RECALL

R20AW Drag Link Castle Nut Torque

Models Affected: Certain Model Year 2019 - 2021 Vision buses.

Fig. 1

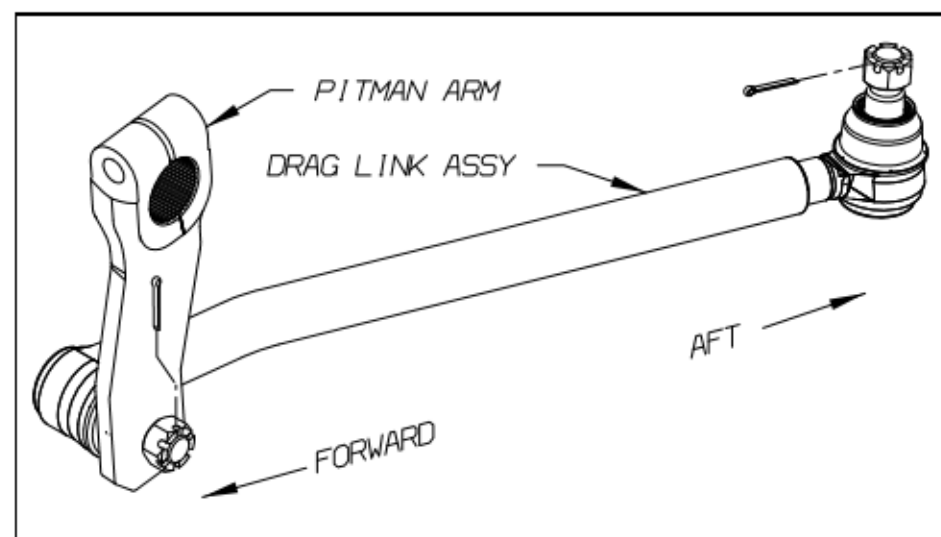
Issue: The castle nuts on both ends of the drag link assembly may not have been installed according to manufacturer's installation specifications.

Corrective Action: Verify the castle nuts on both ends of the drag link assembly are torqued properly.

1. Park bus on a level surface, apply parking brake, switch engine off, remove ignition key and chock wheels.
2. Remove cotter pin from ball stud on forward (pitman arm) end of drag link. (Fig. 1)
3. Torque castle nut on drag link ball stud to 120 ft-lbs.
4. Remove cotter pin from ball stud on aft (steer arm) end of drag link. (Fig. 1)
5. Torque castle nut on drag link ball stud to 120 ft-lbs.
6. Install cotter pins.
7. If castle nut slot for cotter pin does not line up with through hole in each ball stud, tighten castle nut until next slot aligns with through hole. Install cotter pin and bend-over pin tails. **WARNING: Do NOT loosen castle nut to line up slot with through hole in ball stud. Always tighten castle nut to align slot with through hole.**
